Report: TAB Report
Function: Test, Adjust, & Balance
Date: 12/12/2025
Completed By: National TAB

PROJECT
02-02-26 QT #1176 CAYCE, SC

Issue List

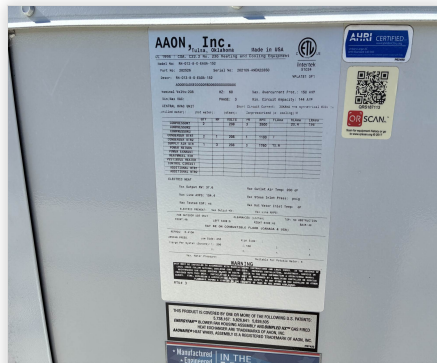
Issue Name : RTU-3 Economizer Actuator Malfunction
Description : The actuator for the economizer stopped responding to commands from the store computer when setting the outside air when the hood is off. The outside air was set manually.
Created By : National TAB **Assigned To :** National TAB - Dan Hertenstein
Status : Open
Priority : Urgent **Asset Tag :**
Originated Date : 02/03/2026 - Alex Bauer - National TAB

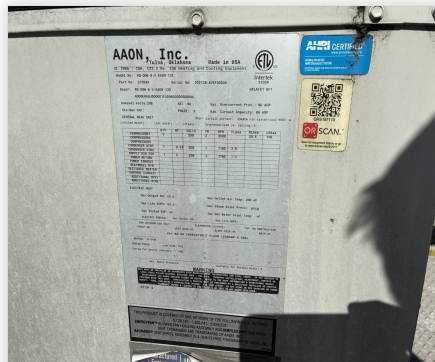
Issue Name : RTU-4 Low Flow
Description : The Yaskawa J1000 VFD is set to its maximum speed option and the RTU is not producing enough airflow as it should (79%/100%). It is recommended to ensure the dampers are fully open and existent as well to check for resistance in the system. 66 CFM/ton is within the acceptable range for a unit of this size.
Created By : National TAB **Assigned To :** National TAB - Dan Hertenstein
Status : Open
Priority : High **Asset Tag :** RT-4
Originated Date : 02/03/2026 - Alex Bauer - National TAB
